ADDENDUM #1 – June 20, 2016

Bid#44-16

McDONOUGH, BREWSTER AND LANGDON STREETS, AREA 3B

**PLAN AND PROFILE
OF
BREWSTER STREET
PHASE 3B
PORTSMOUTH, NEW HAMPSHIRE**

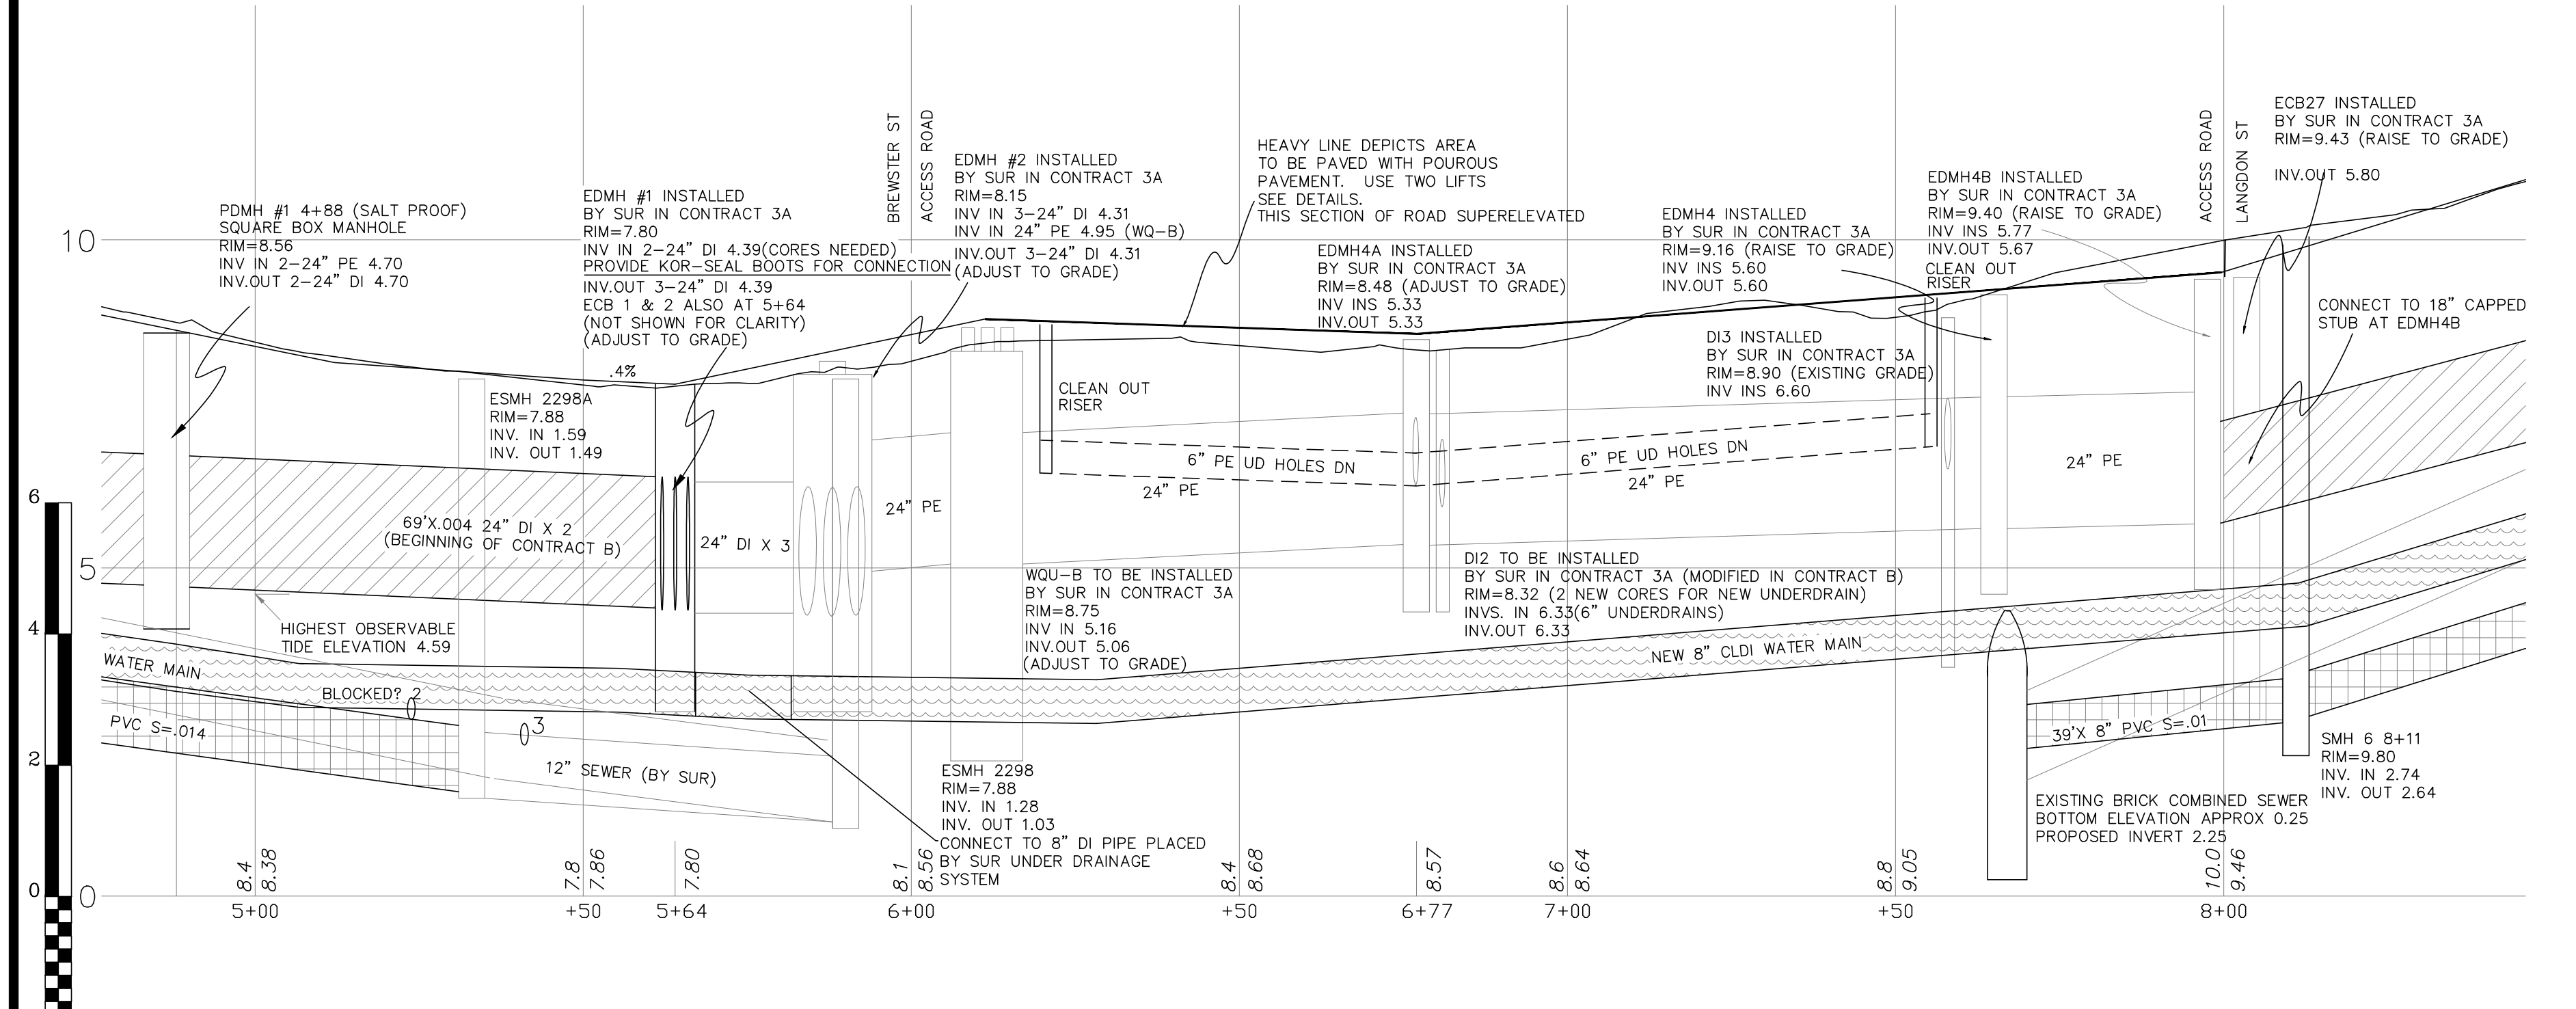
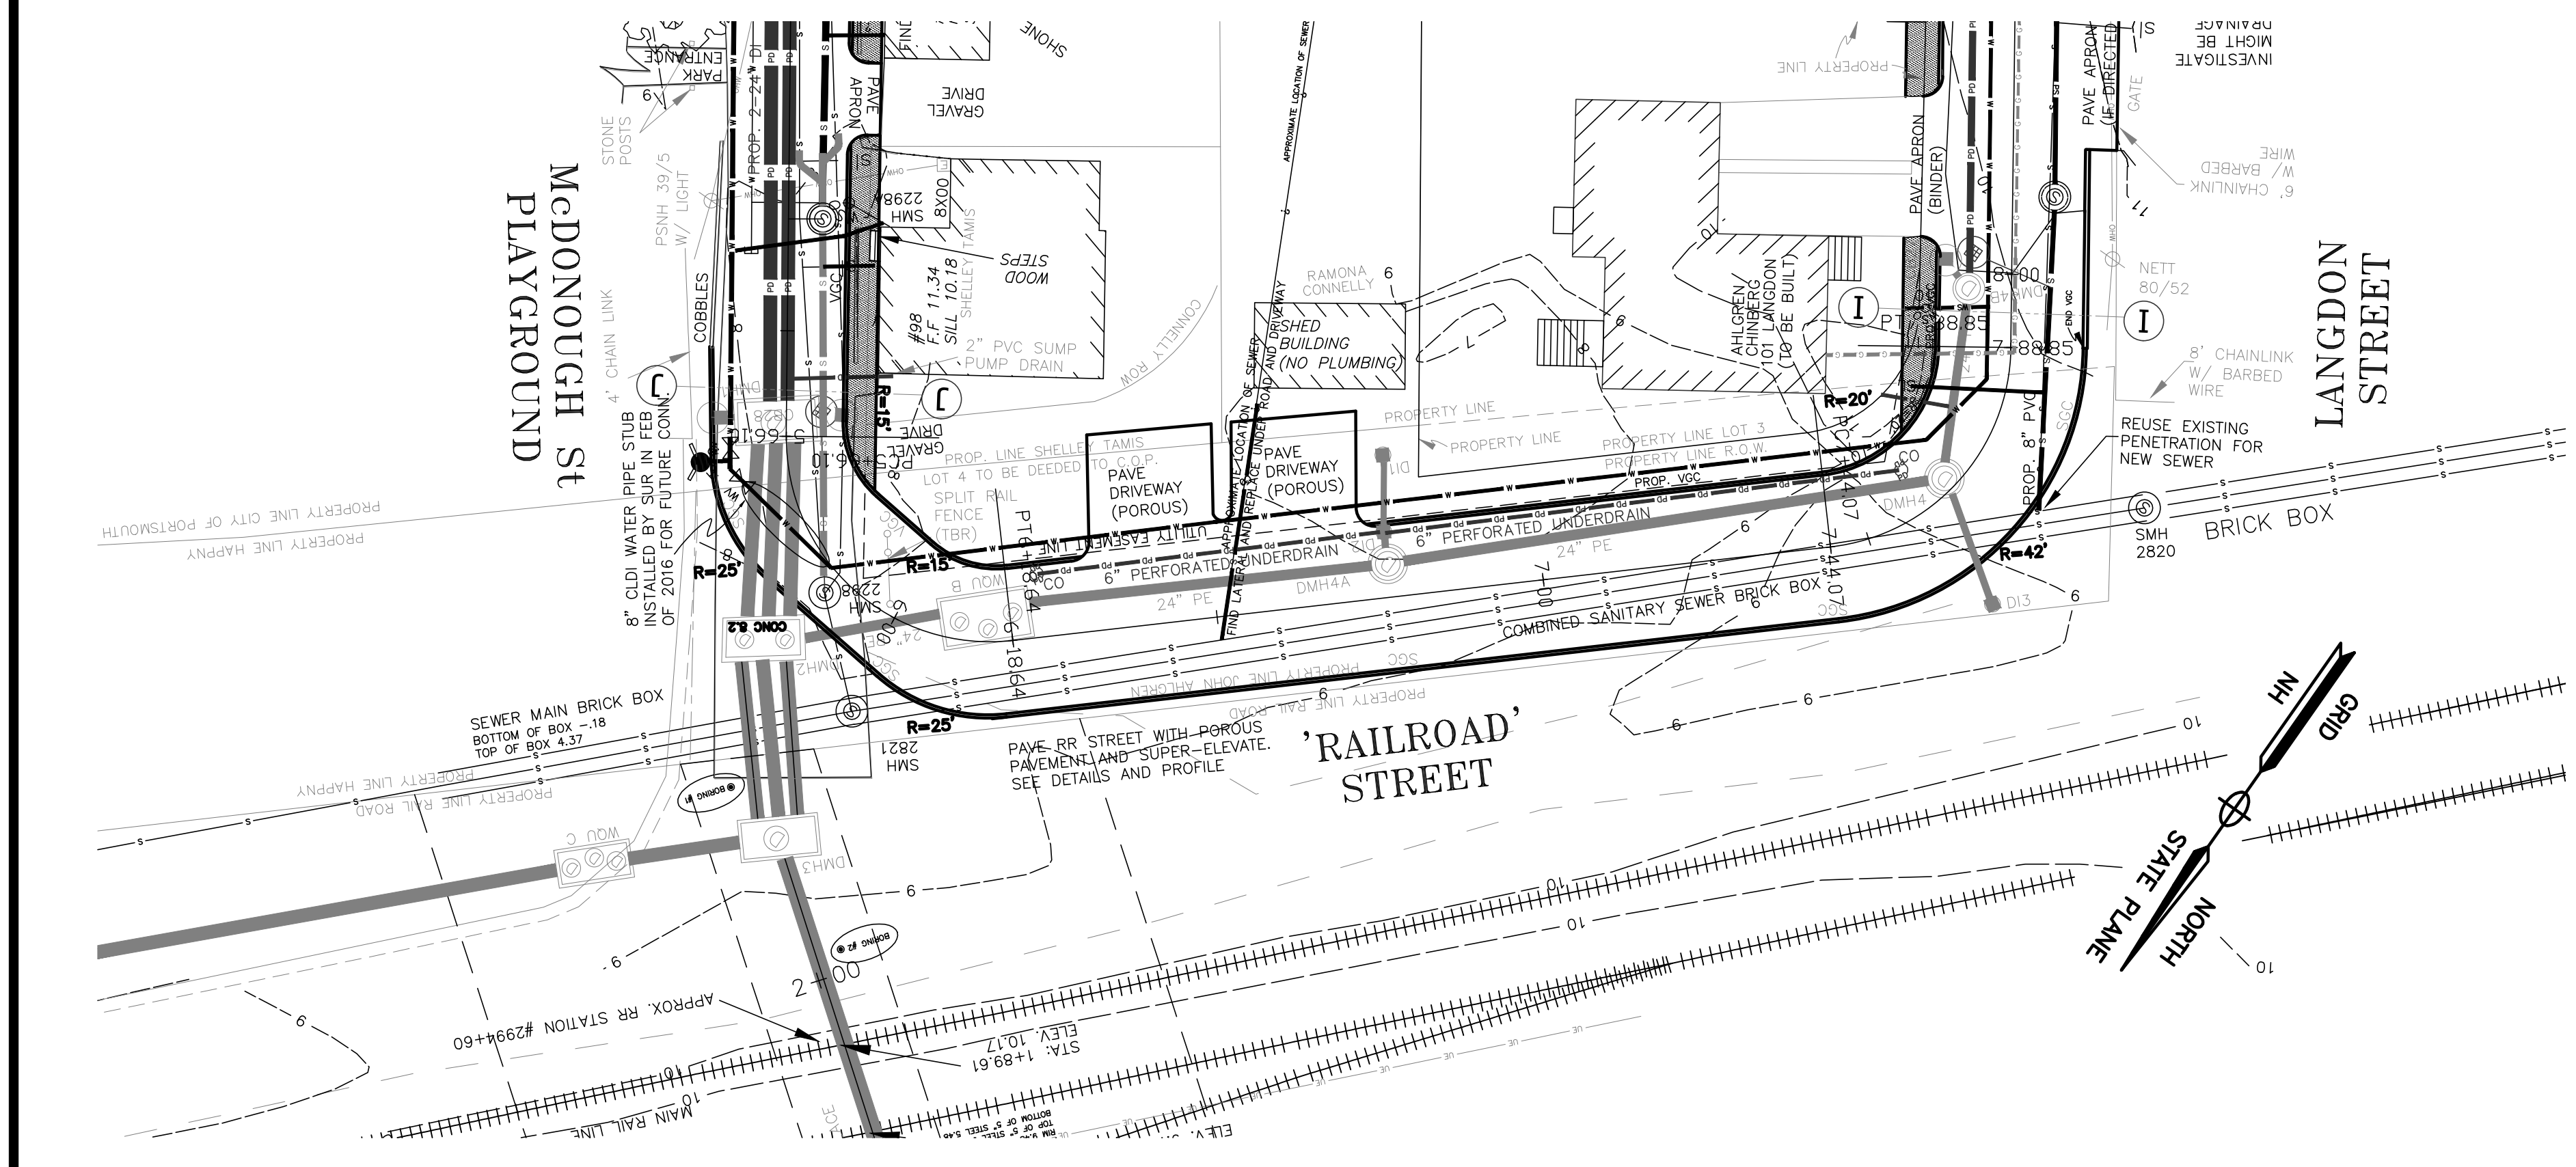
Q During the pre-bid meeting it was mentioned that there was an error in the scale of the contract drawings. While trying to complete a takeoff of the quantities I have found that the lengths of the stationing on the plans are over 11% more than the scale bar included in the legend. While the lengths included in the profile do agree with the scale bar included in the legend. Which scale is correct?

| NO. | DESCRIPTION | DATE |
|-----------|---------------|---------|
| 1 | CORRECT SCALE | 6/20/16 |

A *The scales of the drawings 2, 3, & 4 of 9 originally posted online were inaccurate. Revised drawings are included in this addendum.*

STREET PLAN
OF
RAILROAD STREET AREA
PHASE 3B
PORTSMOUTH, NEW HAMPSHIRE

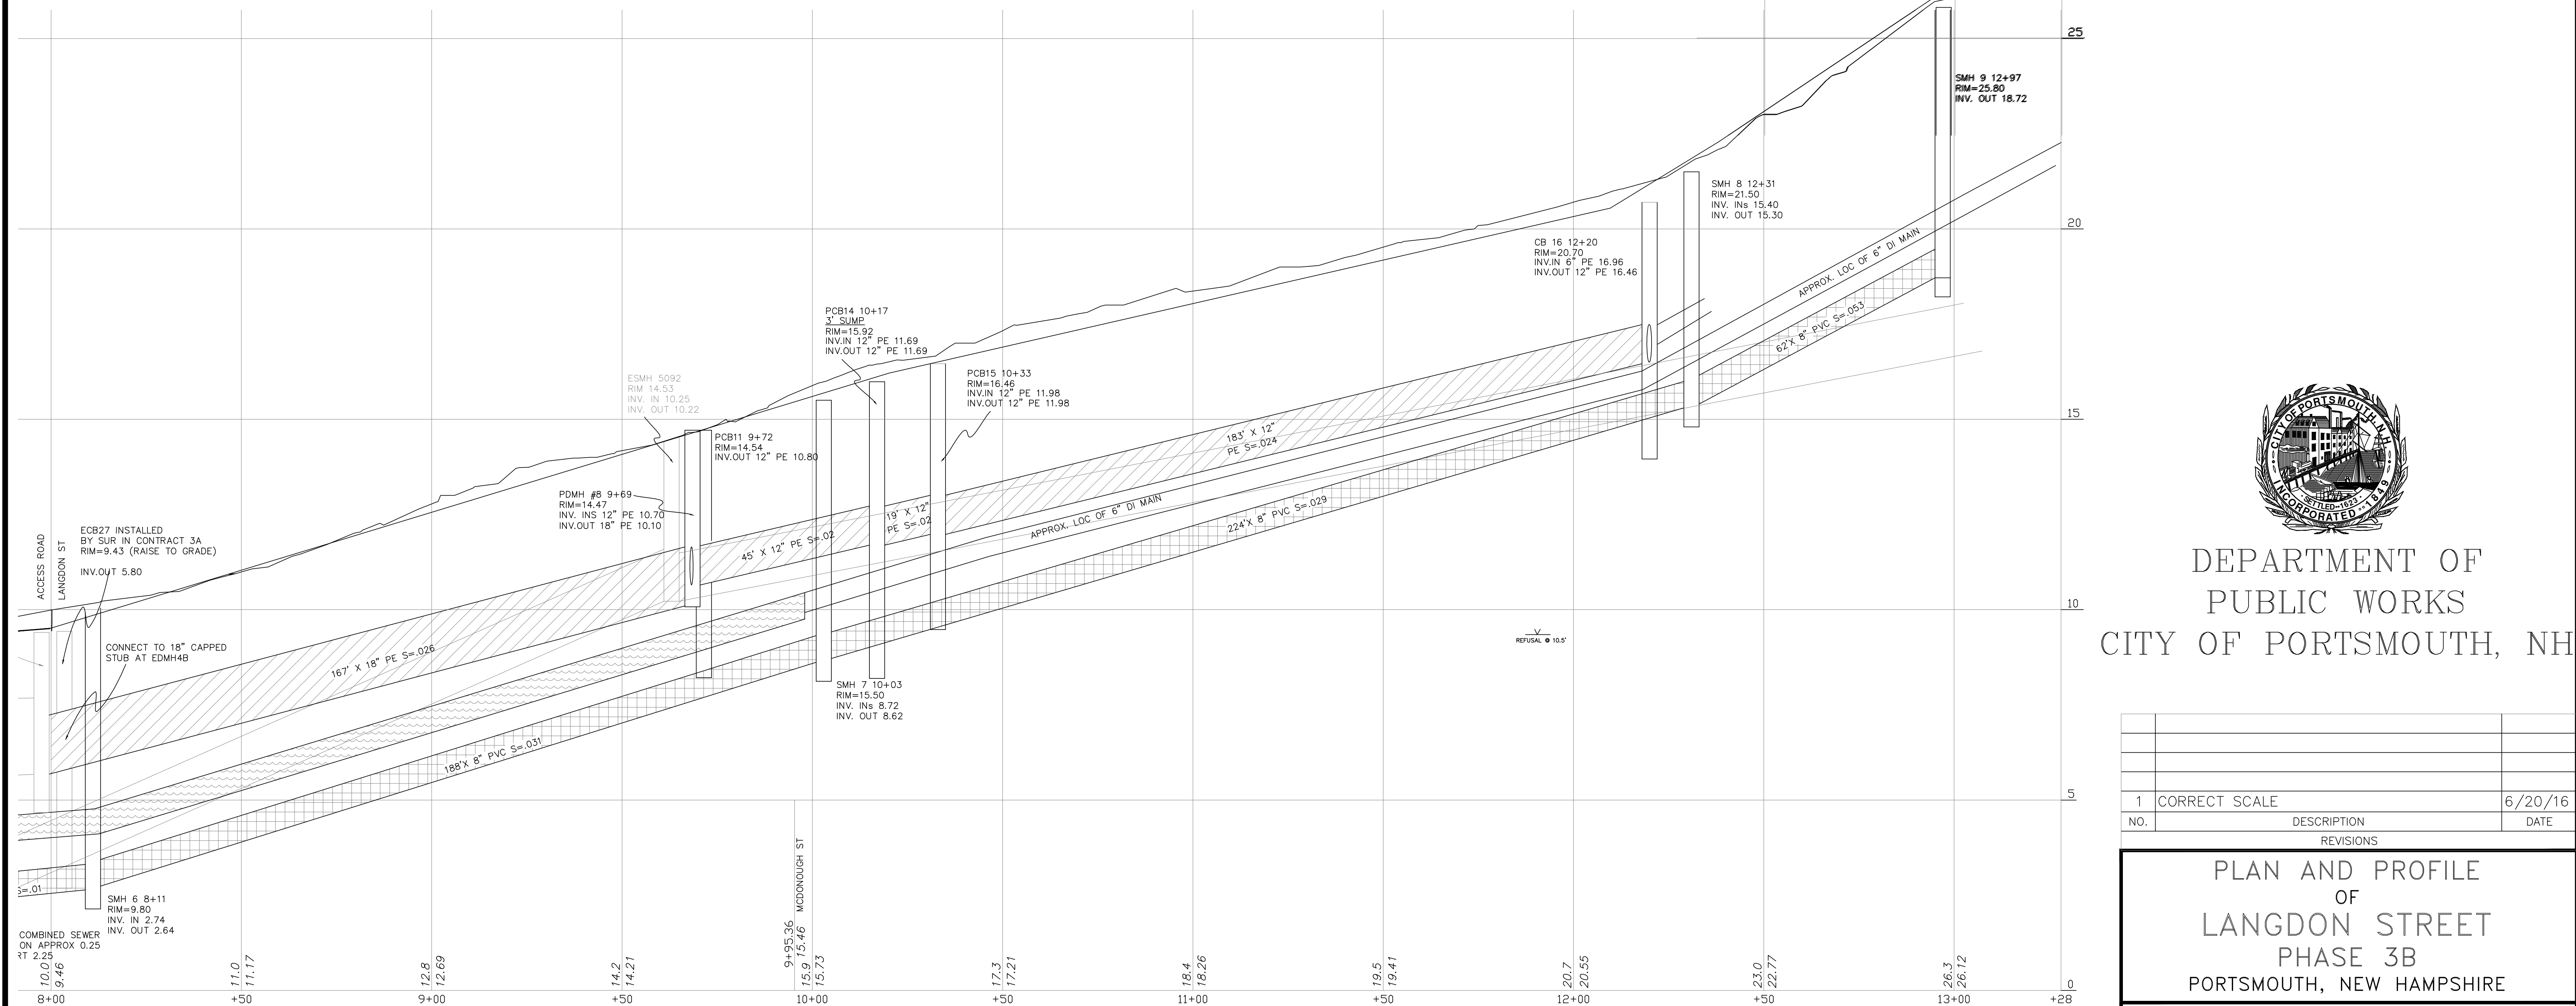
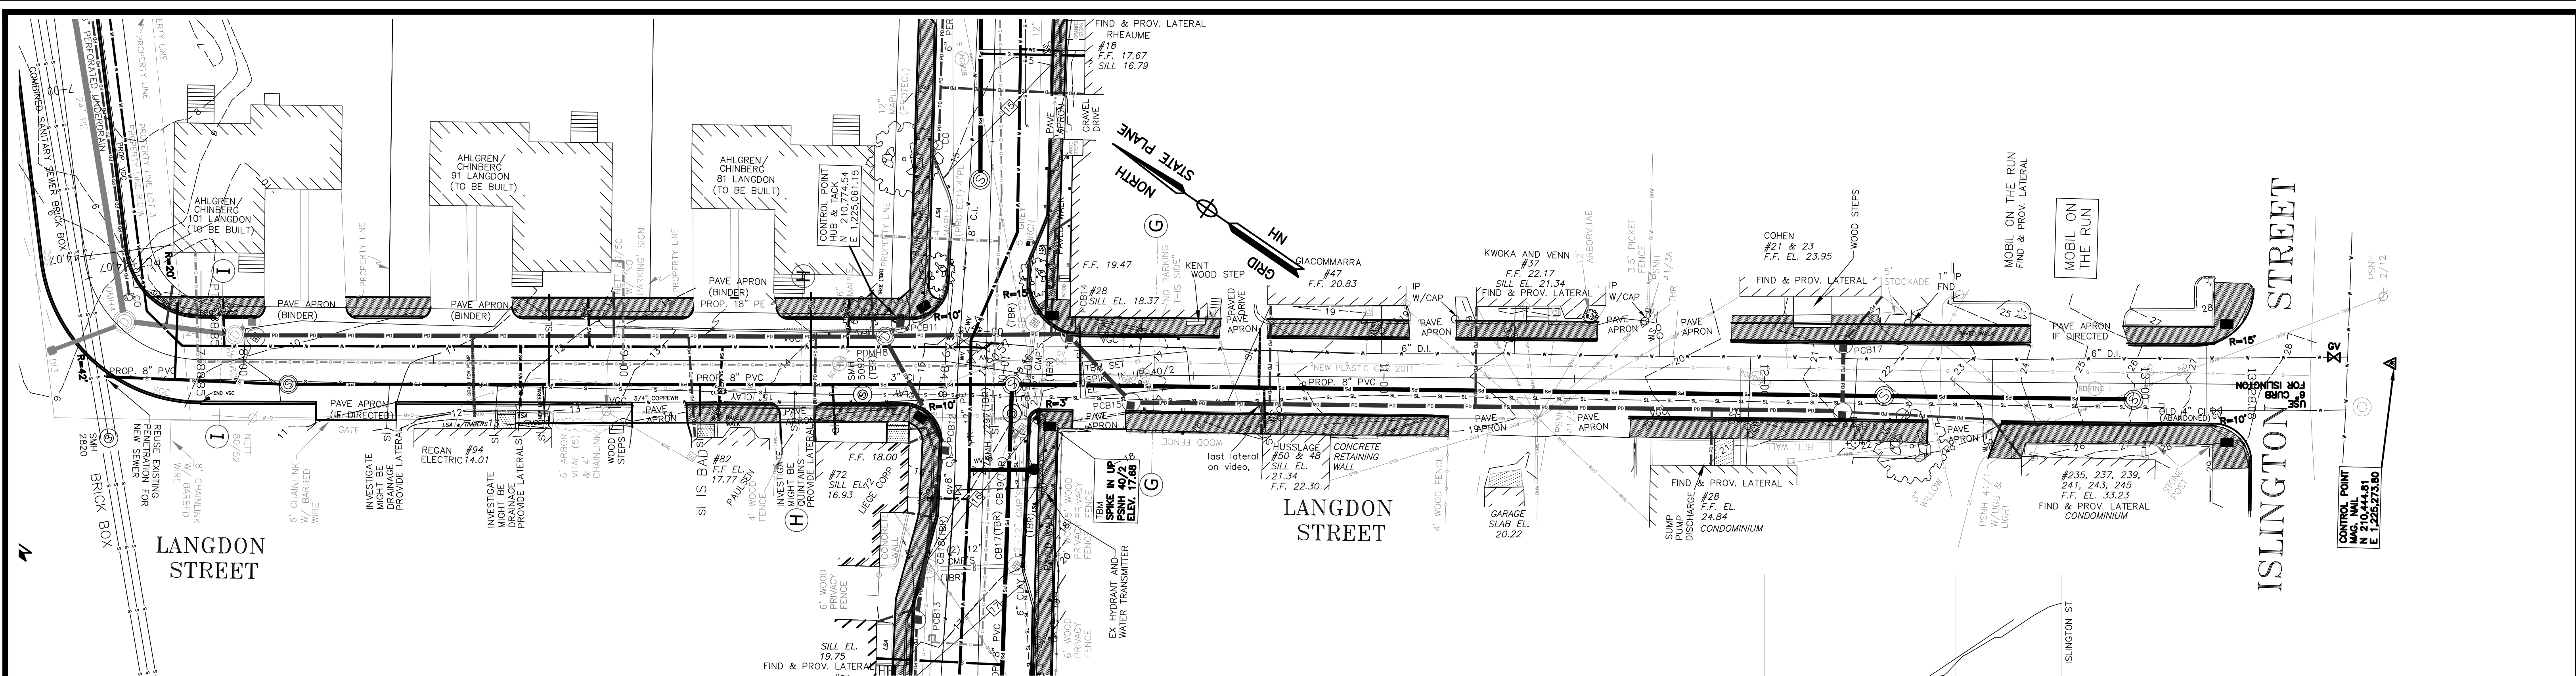
| 1 | CORRECT SCALE | 6/20/16 |
